14. DESCRIPTION OF AMENDMENT/MODIFICATION *(Organized by UCF section headings, including solicitation/contract subject matter where feasible.)*
FY05 OMA Pkg A-155, Rockfall Hazard Mitigation, Tripler Army Medical Center, Island of Oahu, Hawaii

QUESTIONS AND ANSWERS TO W9128A-04-R-0015

Photograph 14 – Showing Cliff Area #1
(Am0006)

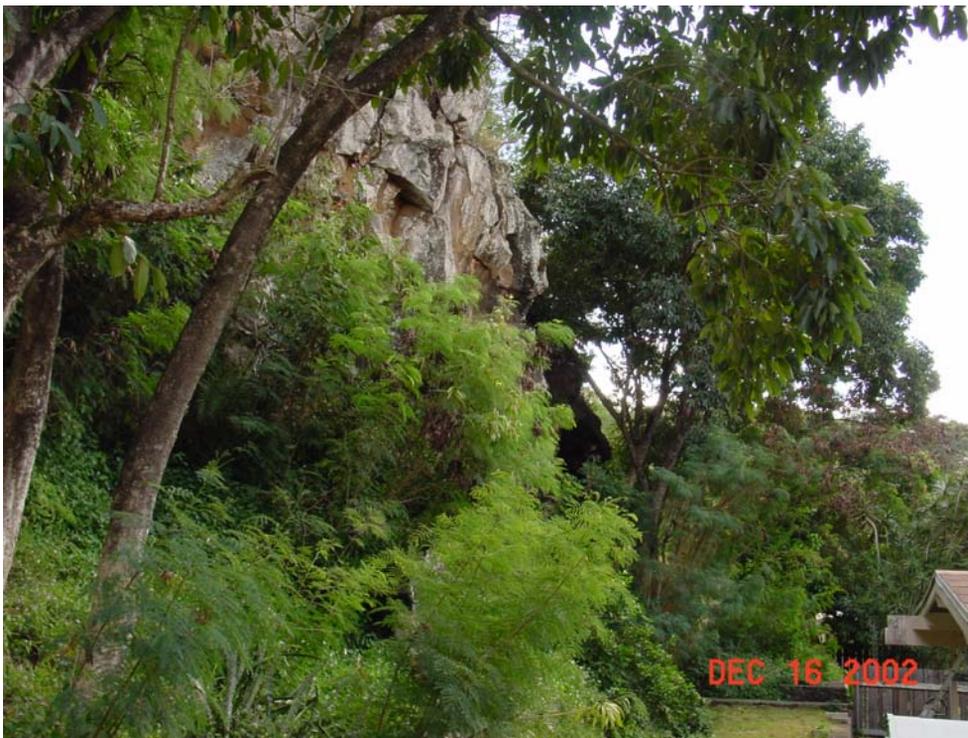
Q6. I still need some clarification as to what work is to be done with what is termed Cliff Area 1. Figure 4 shows 4 separate lines of rock outcroppings. Cliff Area 2 one would assume is the approx. 100' section next to the writing on the figure Cliff Area 2. Cliff Area 1 is not so clear, could you please clarify which part of the rock outcroppings are to be mitigated is it a 100' section or which part of the sections shown is it?

A6. Please see the attached pictures for clarification on Cliff Area #1 (2 Pages).
